UNITED STATES PATENT AND TRADEMARK OFFICE

Final Office  
Action  
10-22-05 (-1 date)

**Office Action Summary**

10/776,872

Drnevich et al. discloses a cryogenic air separation-blast furnace system as shown in Fig 1 below.

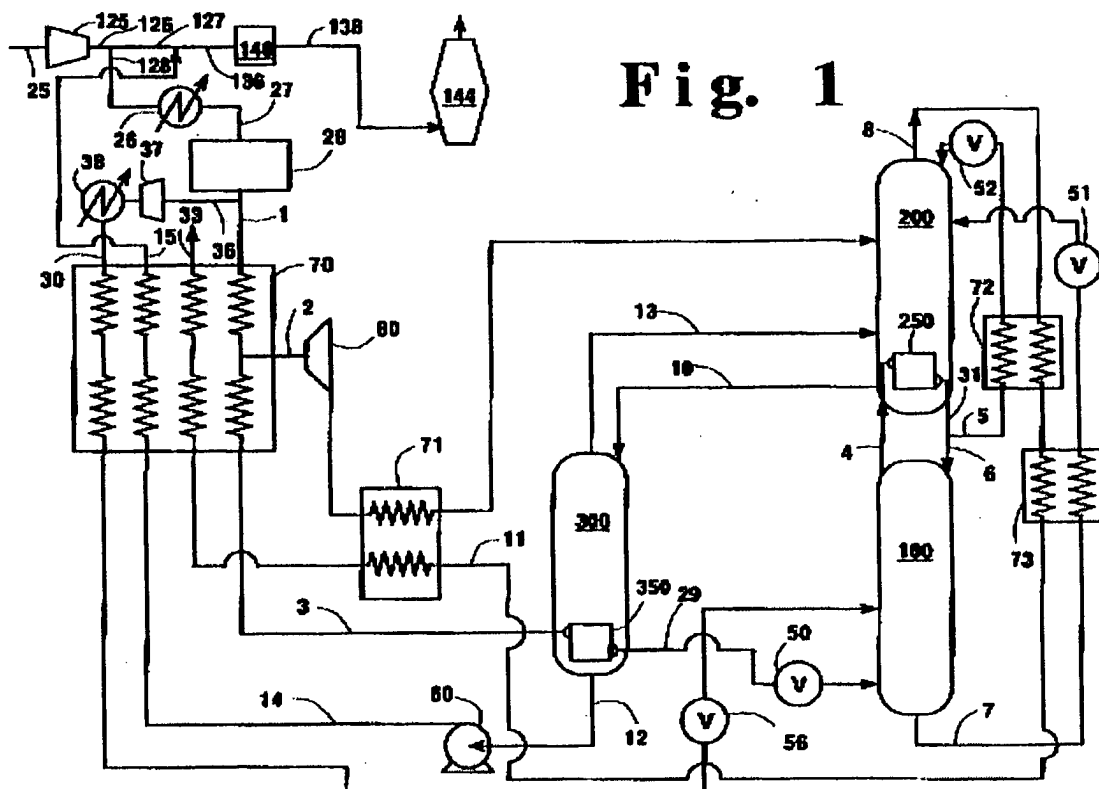
In Drnevich et al., the blast furnace air stream (25) is compressed in a blast air blower (125). A minor portion of the blast furnace feed air stream (126) is taken off (stream 128) as feed to the air separation unit. A primary portion of the blast furnace feed air stream (stream 127) is fed to the blast furnace (144), after being first mixed with the oxygen rich stream (15) returning from the air separation unit. These two streams are combined to form an oxygen-enriched blast air stream (136), which is fed to the blast furnace (col. 4 line 21 to col. 6 line 4).

Drnevich et al. discloses the removal of nitrogen from the upper portion of the separation column (200) as stream 8, warming the nitrogen through heat exchangers 72, 73, 71 and 70, but does not disclose expansion of the nitrogen to recover energy (col. 4 lines 11-20). In a method for air separation combined with a blast furnace, Rathbone (5,268,019) discloses that it is known to be advantageous to recover work from nitrogen produced in cryogenic air separation plants (col. 1, lines 9-28). Rathbone discloses a method for removing a minor portion of the compressed air stream for separation, separating this minor stream into oxygen and nitrogen rich streams, and expanding the nitrogen stream to recover external work (col. 8, line 44-col. 9, line 4).

It would have been obvious to one of ordinary skill in the art at the time the invention was made, to recover work by expanding the nitrogen rich stream generated in Drnevich et al., by any of the means disclosed in Rathbone for heating and expanding the nitrogen to recover work, since Rathbone teaches that it is known to be advantageous to recover work from nitrogen produced in a cryogenic air separation plant (col 1., lines 11-27).

**Fig. 1**

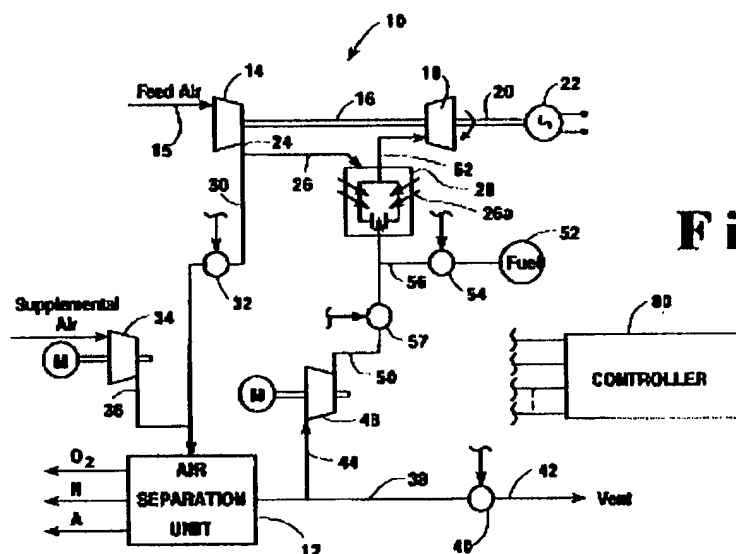
separation unit and gas turbine system, as shown in Fig. 1 below. The feed air stream 15 is compressed (14) then fed to an air separation unit (12). Supplemental air is provided by a compressor (34) (col. 2 lines 46-64). The supplemental air source is provided as part of a control system so that the system can operate at peak performance over a wide range of ambient air temperatures (col. 1, lines 42-52).

It would have been obvious to one of ordinary skill in the art at the time the invention was made to include a supplemental air compressor in the invention of Drenevich et al (US 5,582,036) in view of Rathbone, so that the system could operate at peak performance over a wide range of ambient temperatures as disclosed by Drenevich (5,802,875; col. 1, lines 42-52).
